LAVALLEE | BRENSINGER ARCHITECTS

ADDENDUM NO. 6
March 24, 2016

Re: Sanford High School and Technical Center
12-067-00

J1 A1.64 LEVEL 2 RCP - AREA C1
1/8" = 1'-0"

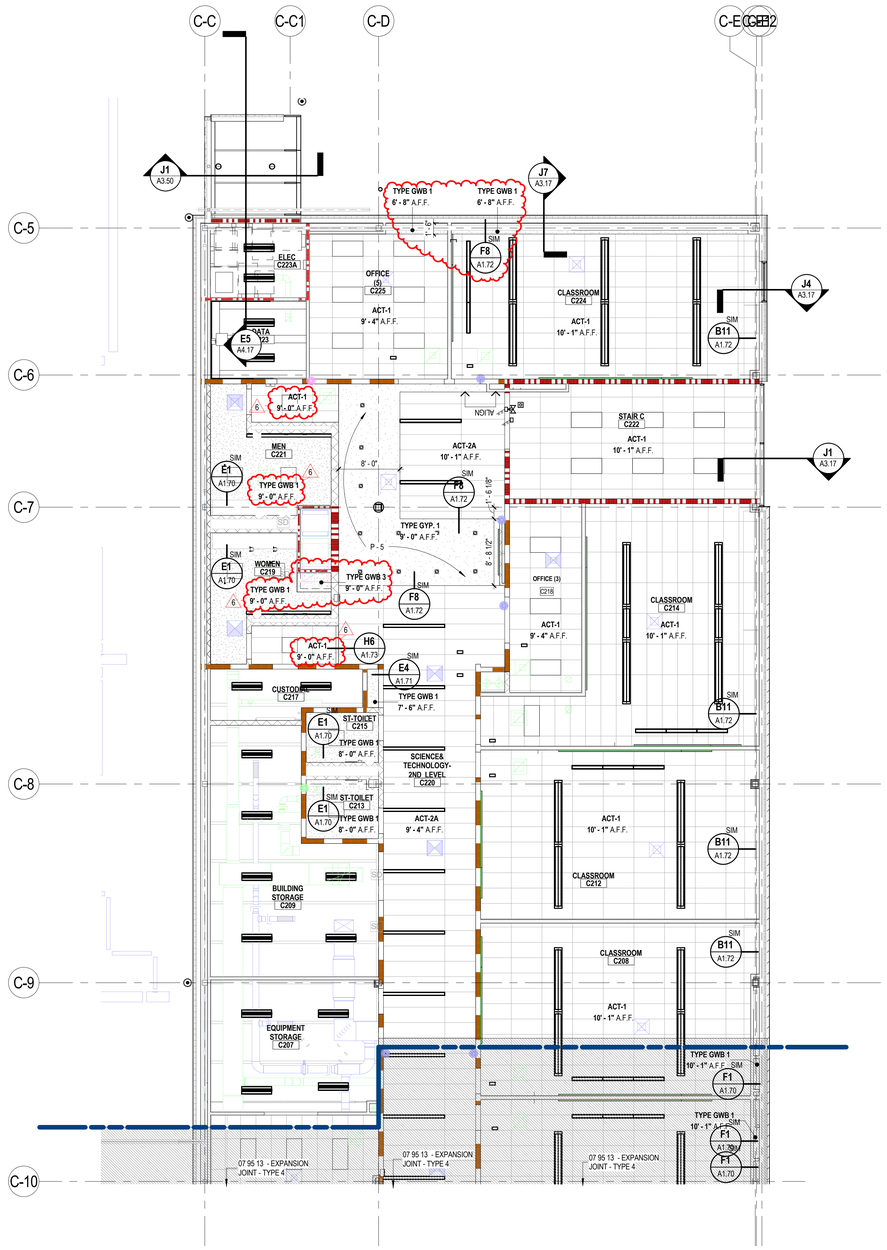
Item No. 6.12 **Reference Drawing S1.25:** Revise beam size in wing C to W18X86 as shown in attached SKS-01. Refer to revised drawing A1.64 for revised soffit height. Refer to revised A1.24 for added F3 partition in Office C225.

J1 A3.35 SECTION DETAIL OF MASONRY FACE WITH STUD BACKUP AND ROOF
3" = 1'-0"

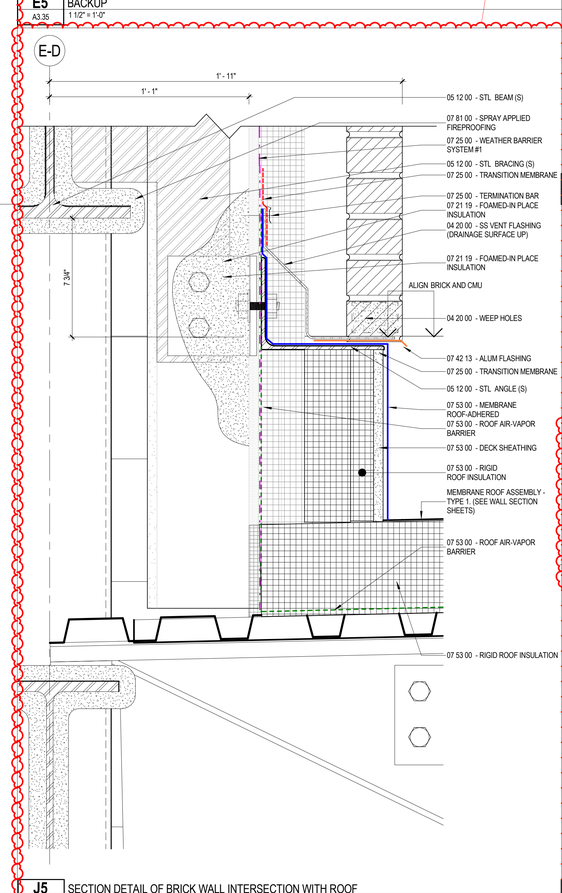
Item No. 6.20 Reference Drawing J1/A3.35 Question: J1/A3.35 shows the metal flashing embedded in masonry over the roof as 07 62 00. E7/A3.36 shows this same flashing as 04 20 00. Please clarify who is to supply this flashing.
Answer: See updated Drawings

E7 A3.36 SECTION DETAIL OF BROW AND CURTAIN WALL AT DINING ENTRY
3" = 1'-0"

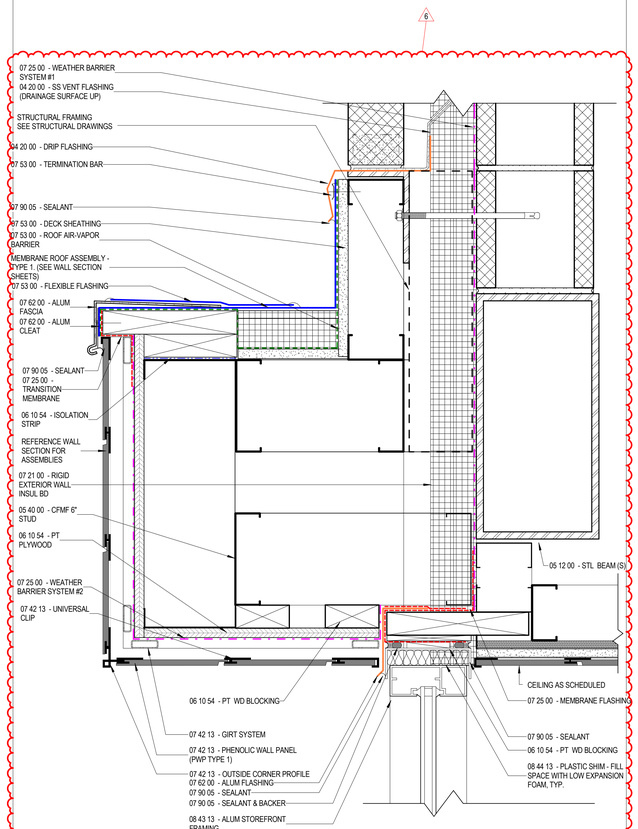
Item No. 6.21 Reference Drawing E7/A3.36 Question: E7/A3.36 shows 04 20 00 Vent Flashing being installed to the face of sheathing over the roofing material and left exposed. Is this correct? Is Division 04 responsible for supplying and installing this material even though it is not part of the masonry assembly?
Answer: See updated Drawings
